3 Volt Intel StrataFlash[®] Memory

28F128J3A, 28F640J3A, 28F320J3A

Specification Update

Order Number: 298130-012

Figure 1. AC Waveform for Standard Word/Byte Read Operations

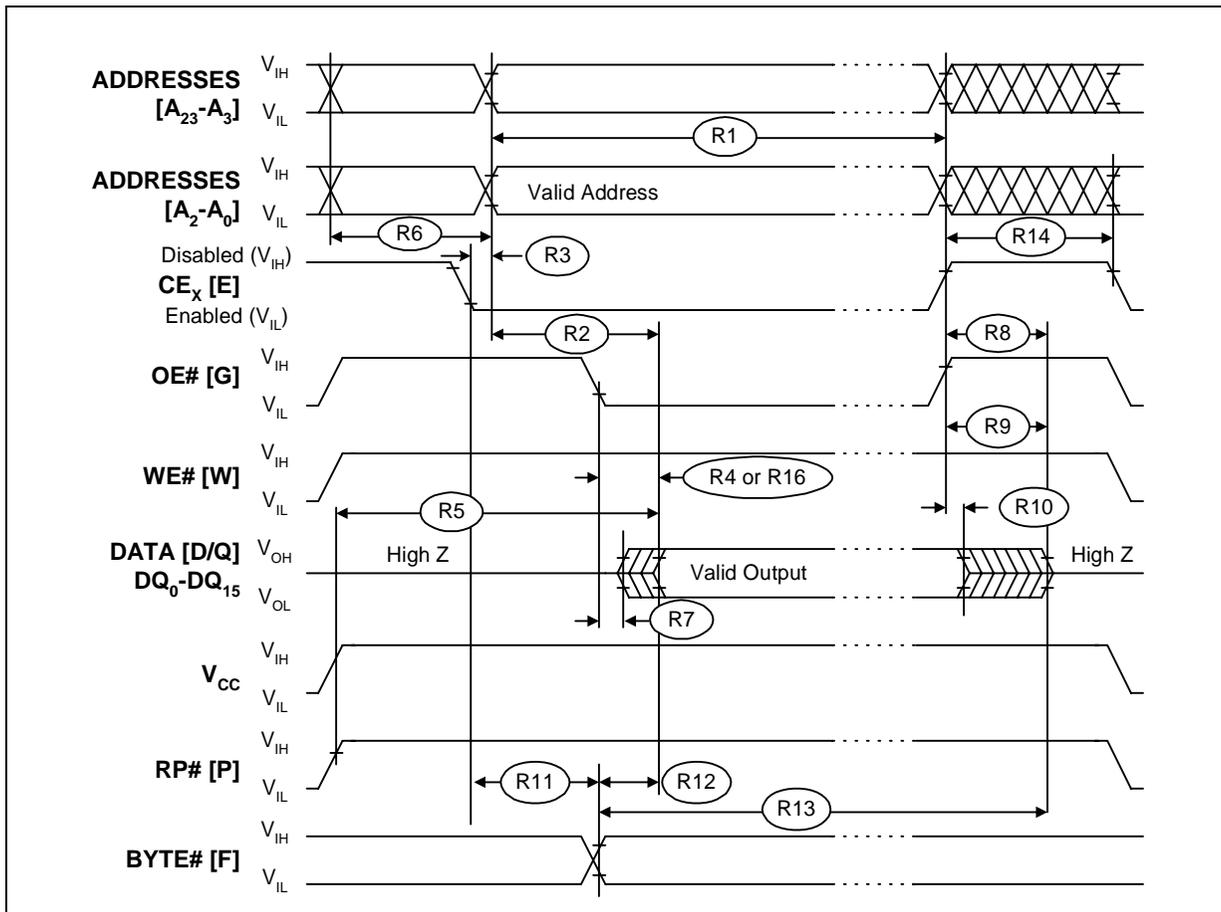
Problem: Devices need the parameter $t_{ELQX} = 150$ ns minimum. CE low to output in low Z (t_{ELQX}) is designated as R6 in Figure 1, in this Specification Update revision.

Problem: Devices need the parameter $t_{ELAV} = 500$ ns maximum. Chip Enable to Address Valid (t_{ELAV}) is designated as R3 in Figure 1, in this Specification Update revision.

Workaround: Use devices for initial lower volume prototype development.

Workaround: Use devices for initial lower volume prototype development.
